SWCPP Ref. No.:	PPSSWC-69
DA No.:	DA20/0167
PROPOSED DEVELOPMENT:	Construction of Part Seven (7) Storey & Part 46 Storey Mixed Use Development including Four (4) Storey Podium containing Basement Parking, Retail Premises & Car Parking, Office Premises, Serviced Apartments with 35 Suites, 272 Residential Apartments & Associated Site Works - Lot 10 DP 1162271,614 - 632 High Street, PENRITH NSW 2750
APPLICANT:	Urban Property Group
REPORT BY:	Kathryn Saunders, Senior Development Assessment Planner, Penrith City Council

Assessment Report

Figure 6 (above): Excerpt from PDCP 2014 - Precinct 1 Design Principles - Figure E11.26

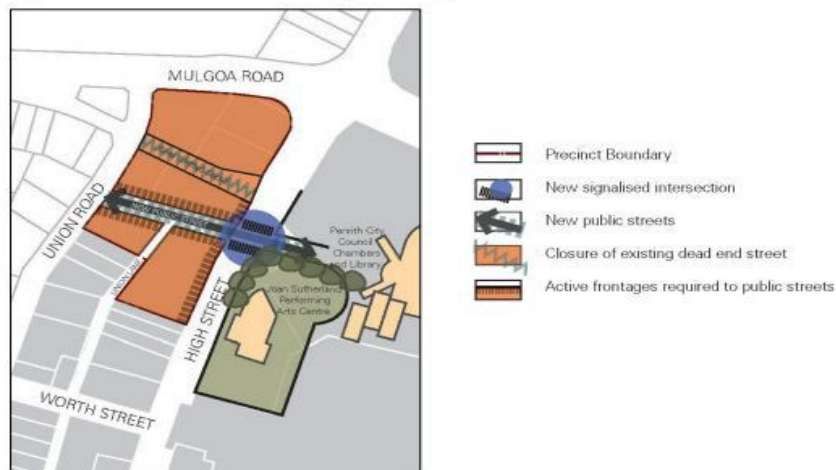
The proposed development does not assist in the delivery of the above and the infrastructure proposed as part of the applicant's CI offer is not shown on the plans and as such a proper assessment of the public domain surrounds the development cannot be undertaken.
